Two Rivers Pit M-1998-038 AM1 Third Adequacy Review

RE: Fremont Paving and Redi Mix, Inc. Two Rivers Pit M-1998-038 Amendment Application (AM-1), Third Adequacy Review

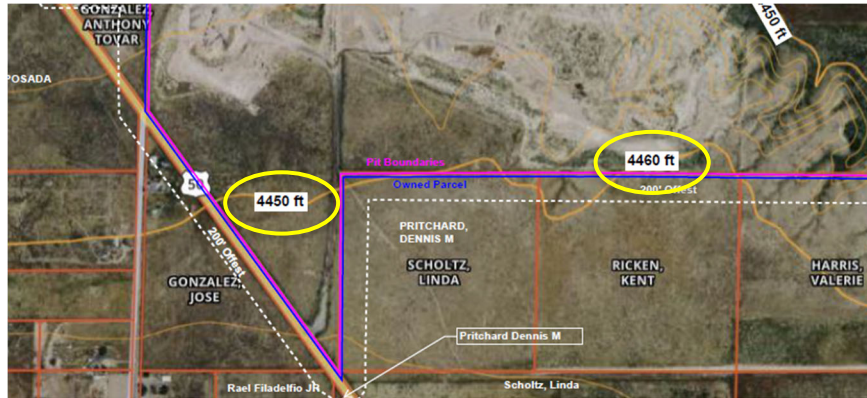
2. The map titled “Existing Conditions – Land Owners Exhibit C.4” provides information regarding the topography with sufficient detail to portray the slope and direction of rate of slope change based on the current site conditions, per Rule 6.4.3(c). However, the southern index contour line has two values assigned to it: 4450 feet and 4460 feet. Please revise the map to clarify the correct elevation. See the below image.

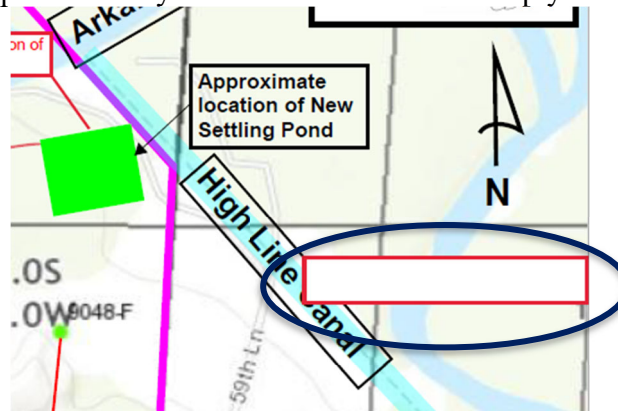
3. The map titled “Two River Pit Existing Conditions – Wells Exhibit C.3” has a red label box that is blank, please clarify the label or remove the empty box. See the below image.
